**Summary of November 2015 Discussion of Draft Limitations and Conditions and
Supplemental Information for the FULL SPECTRUM LOCA (FSLOCA) Evaluation Model
(Non-Proprietary)**

December 2015

Summary of November 2015 Discussion on Draft Limitations and Conditions and Supplemental Information for the FULL SPECTRUM LOCA (FSLOCA) Evaluation Model

Figure 3-3: Figure 17 from AEP-NRC-2009-23, D. C. Cook Unit 2 ASTRUM Analysis Containment Pressure Comparison

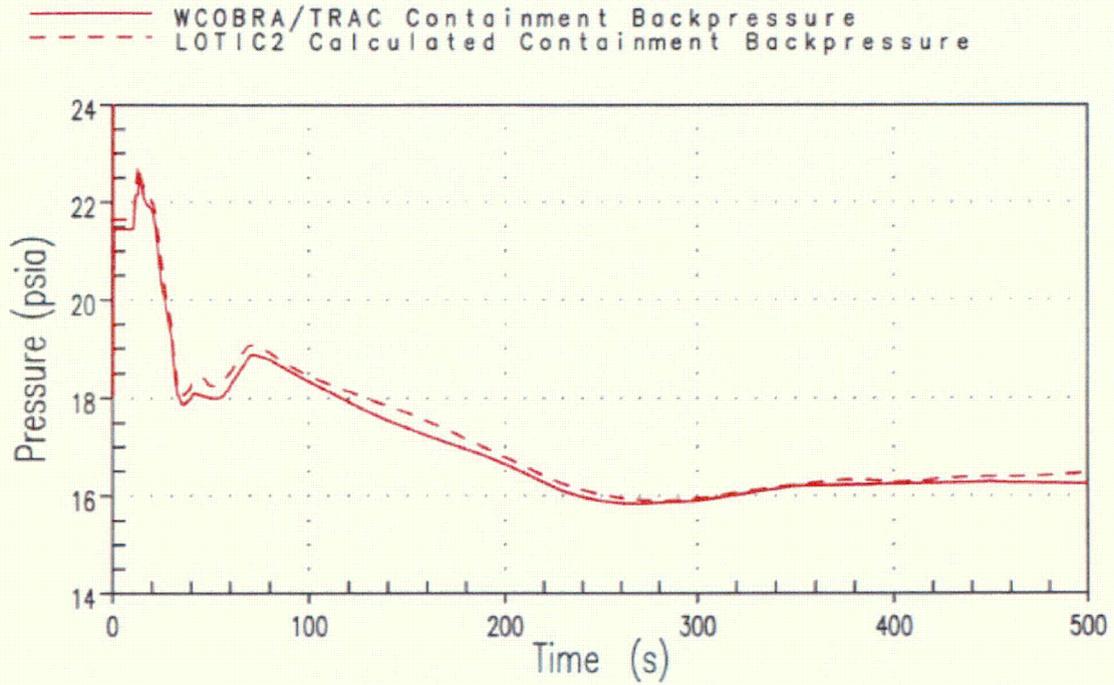
As previously mentioned, the D. C. Cook Unit 2 WCOBRA/TRAC reference transient input containment pressure and the associated LOTIC2-calculated containment pressure are shown in the figure on page 26 of Enclosure 2 to AEP-NRC-2009-23 for the ASTRUM analysis. This figure has been included herein as Figure 3-3.

The process previously outlined was used to determine an appropriate containment pressure boundary condition for WCOBRA/TRAC-TF2 within the FSLOCA EM. A WCOBRA/TRAC-TF2 transient with conditions as similar to the ASTRUM reference transient as reasonably achievable was used (recognizing that there will be some differences in the mass and energy releases from the ASTRUM case). A comparison of the assumed WCOBRA/TRAC-TF2 containment pressure boundary condition versus the LOTIC2-calculated containment pressure is given in Figure 3-4. It can be seen that [
